RE: Comments of June 27, 2006
APPLICATION: T3S-PPC-1000-E ELVA-1 Ltd.

WLL Project: 9096

The following is a typical display from BER tester.

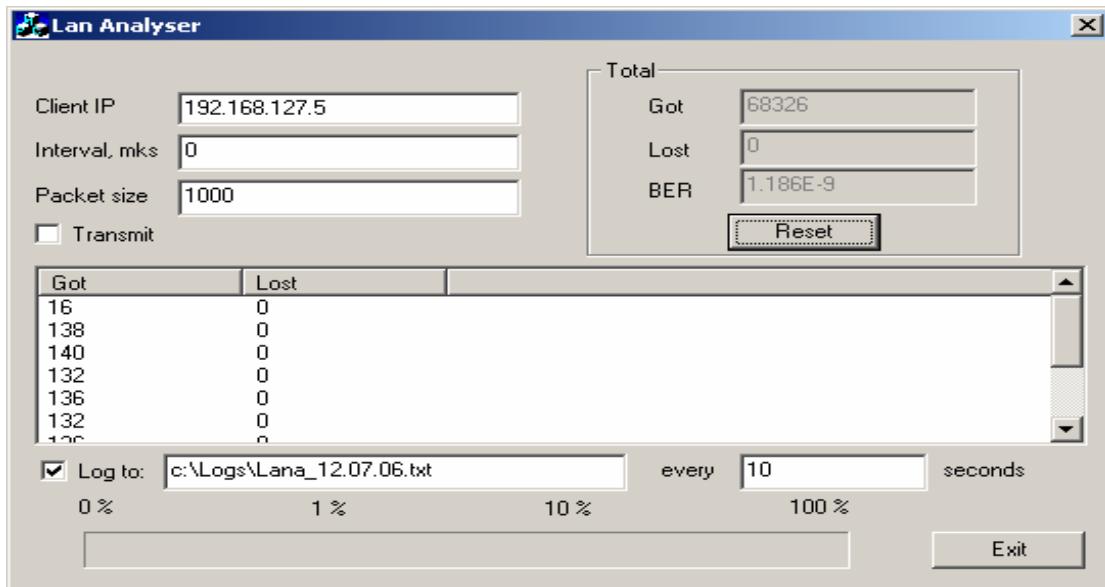
5) It does not appear that a Tune up procedure over the power range has been provided? (2.1033(c)(9)). Please review.

R. The report has been updated with this information:

During equipment tune up, the following equipment is used: Power Meter, Spectrum Analyzer with external mixer and mm-wave source. Output power and spectrum width are measured for each radio.

For additional information we compare theoretical sensitivity of receiver and measured sensitivity at BER 10^{-9} . If the spectrum or output power are not correct, then BER will be affected.

The radio is connected over a waveguide path and Gigabit Ethernet traffic is sent from PC to another one over the radio link. We increase attenuation and check Voltage of AGC output of the radio and BER on a PC.

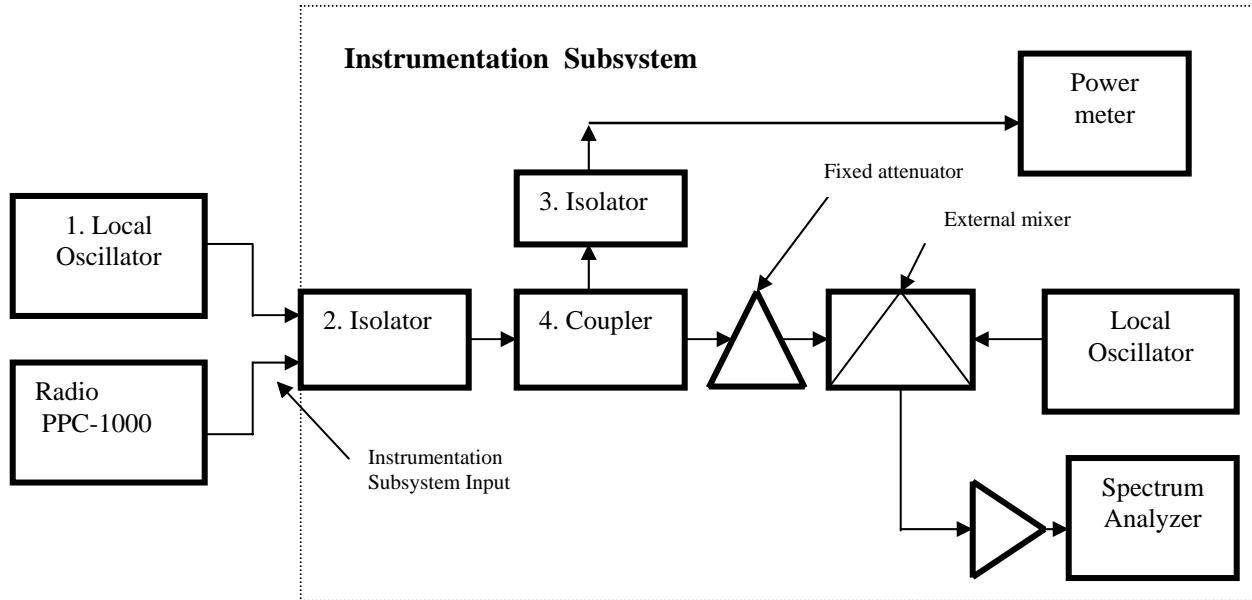
8) It appears that a power meter is used for measuring power. This device is considered as a mmwave device and should follow mm-wave methods for measurement specified by the FCC. Note: The term "millimeter wave" is derived from the wavelengths of radio frequency signals between 30 GHz and 300 GHz, which range between 1 and 10 millimeters as given in FCC 03-248. The mmwave procedures (see attached) preferred method is to follow a radiated measurement due to many reasons given in the document. However the document does mention that a conducted method of measurement could be employed for certain tests if EUT and mixer waveguides both are accessible and of the same type. Additionally, it is uncertain as to the range capability and linearity of the power meter to the frequency range measured. Please provide additional information to support acceptability of the method used and also to cover the concerns raised by the mm-wave procedure in utilizing conducted methods. Alternatively, please provide appropriate RF power measured following the radiated methods specified by the mm-wave procedures. (see provided document)

R. Measurements were made using suitable waveguide and down-conversion to measure the signal path losses

The linearity of the power meter is verified according to the attached document. "Measurement Linearity of Power Meter.pdf". This document has been uploaded.

Calibration waveguide path port1/port3

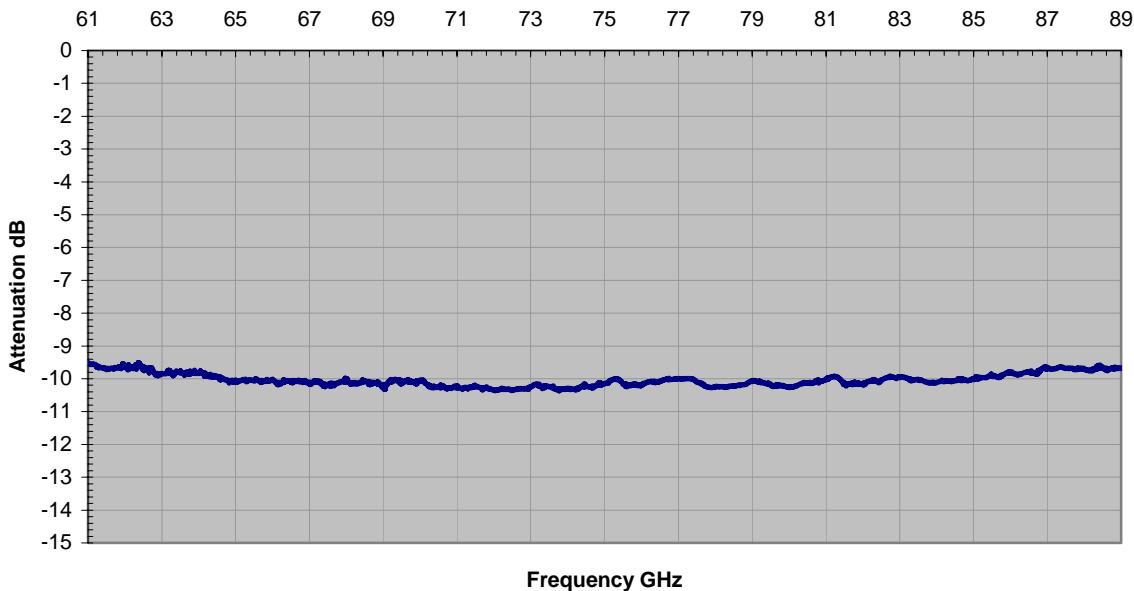
9) There are some questions regarding the calibration of the system in section 4.1. Please explain: how -10 dBm at the power meter ensure an input = 0 dBm at the isolator input? Isn't the purpose to determine the loss? How does the additional attenuator in the spectrum analyzer path factor into this? Additionally, how does the calibration factor in any linearity concerns?

R. The report has been updated with this change

The Local Oscillator output was adjusted to show -10dBm at the power meter; this corresponds with 0dBm at the isolator input. During the sweep, minus 10dBm was maintained at the power meter and the response of the spectrum analyzer was recorded over the frequency range. This allowed for a frequency versus amplitude calibration factor relative to minus 10dBm at the power meter input. Hence, when the PPC radio was connected to the input of the isolator, the response at each frequency, *relative to the -10dBm calibrated level on the power meter*, was established. A correction factor was assembled over the frequency range. This factor appears as an adjusted limit line on the spurious emissions graphs.

Calibration file was applied for keeping power level at the isolator input 0 dBm. Corresponding corrections for each particular frequency were applied according to the calibration file data.

A sample of the calibration plot is presented below.
